STAFF MEMO

Subject: Hammond Road, LLC (applicant/owner) – Review for acceptance and consideration of final approval for a major site plan application to construct a 6,400 square foot office and storage building with associated site improvements. The parcel is located at 0 Nathaniel Drive in the Commercial Zoning District and Groundwater Protection District. Tax Map 43 Lot 69-1

Re: Adam Vaillancourt Roofing Site Plan (Lot 43-69-1) – Drainage Review

**Re: Interdepartmental Review Map 43 Lot 69-1
Vaillancourt Roofing Site Plan**

STORMWATER MANAGEMENT PLAN
MAP 43 / LOT 69-1
ADAM VAILLANCOURT ROOFING & CONSTRUCTION, LLC
STONEYARD DRIVE
TOWN OF MILFORD
HILLSBOROUGH COUNTY, NEW HAMPSHIRE

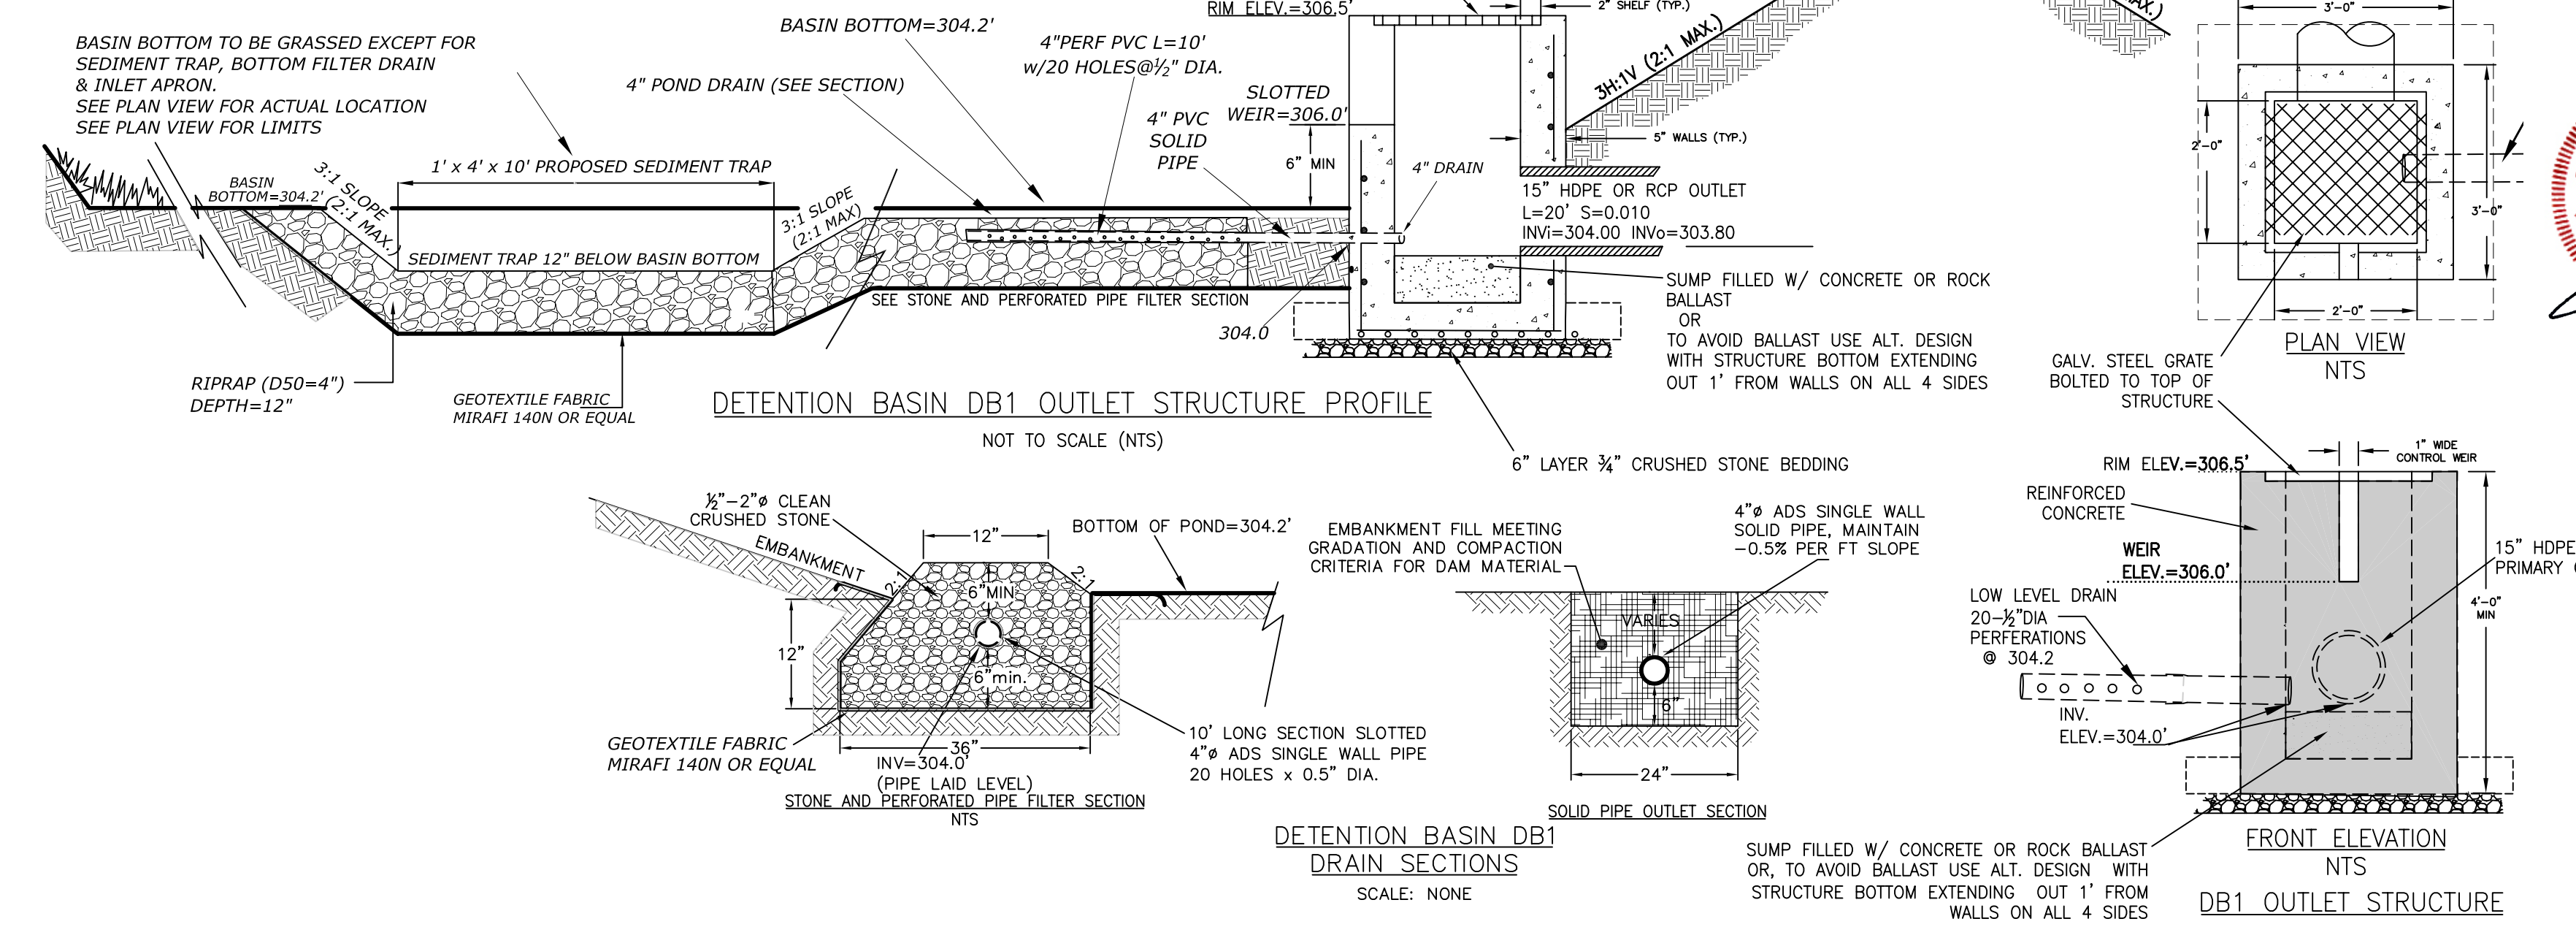
1. A test pit location was noted on the plans in the stormwater basin, but the test pit data was not found. Please provide the test pit data so the basin review can be completed.
2. At the top of the treatment swale a symbol with a double circle is shown. Please clarify what is proposed at this location.
3. The stormwater basin detail depicts stone over the entire basin bottom, but the plan only shows stone in limited locations. Please revise the stormwater basin detail or plan to clarify the design intent.
4. The proposed grading shown on the plans for the treatment swales does not match the grades indicated in the calculations. Please clarify.
5. Clarify how the stormwater flow from the pavement will be conveyed from the gutter (formed by the curb) to the treatment swale.

TEST PIT DATA
STONEYARD DRIVE, MILFORD TAX LOT 43/69-1

TEST PIT NO. 1 (DB1) 7/19/2019 BY EARL SANDFORD NH-1203 GROUND ELEV=307
0" - 6" 10YR 3/3 DARK BROWN, FINE SANDY LOAM FILL, TOPSOIL, FRIABLE, GRANULAR
6" - 20" 10YR 6/8 BROWNISH YELLOW, FINE SANDY LOAM, FRIABLE, GRANULAR
20" - 96" 10YR 7/4 VERY PALE BROWN, LOAMY SAND, FIRM IN PLACE FRIABLE IN HAND, MASSIVE ROOTS TO 60"
HOLE TERMINATED AT 96" = 8" = ELEV 299.0
NO WATER OBSERVED TO 8"
ESHW: 60" EL 302.0
PERC RATE = 8 MIN/INCH IN NATURAL B AND C HORIZON

TEST PIT NO. 2 (TS1&TS2) 7/19/2019 BY EARL SANDFORD NH-1203 GROUND ELEV=309.5
0" - 6" 10YR 3/3 DARK BROWN, FINE SANDY LOAM FILL, TOPSOIL, FRIABLE, GRANULAR
6" - 22" 10YR 5/8 YELLOWISH BROWN, FINE SANDY LOAM, FRIABLE, GRANULAR
20" - 96" 10YR 7/4 VERY PALE BROWN, LOAMY SAND, FIRM IN PLACE FRIABLE IN HAND, MASSIVE ROOTS TO 60"
HOLE TERMINATED AT 96" = 8" = ELEV 301.5
NO WATER OBSERVED TO 8"
ESHW: 60" EL 304.5
PERC RATE = 8 MIN/INCH IN NATURAL B AND C HORIZON

TEST PIT NO. 3 (DB1) 8/14/2019 BY EARL SANDFORD NH-1203 GROUND ELEV=304
0" - 10" 10YR 3/3 DARK BROWN, FINE SANDY LOAM FILL, TOPSOIL, FRIABLE, GRANULAR
10" - 20" 10YR 5/3 BROWN, FINE SANDY LOAM, FRIABLE, GRANULAR
20" - 36" 2.5Y 4/4 OLIVE BROWN (WITH DISTINCT LENSES OF 5YR 5/8 YELLOWISH RED AT 24"), LOAMY SAND, FIRM IN PLACE FRIABLE IN HAND, MASSIVE
36" - 84" 10YR 7/4 VERY PALE BROWN, GRAVELY LOAMY SAND, FRIABLE, SINGLE GRAIN&MASSIVE ROOTS TO 30"
HOLE TERMINATED AT 84" = 7" = ELEV 297.0
NO WATER OBSERVED, NO LEDGE OBSERVED
ESHW: 24" EL 302.0 (ESHW APPEARS AS PERCHED, WELL DRAINING GRAVELEY SOIL BELOW)
PERC RATE = 10 MIN/INCH IN NATURAL B AND 6 MIN/INCH IN C HORIZON
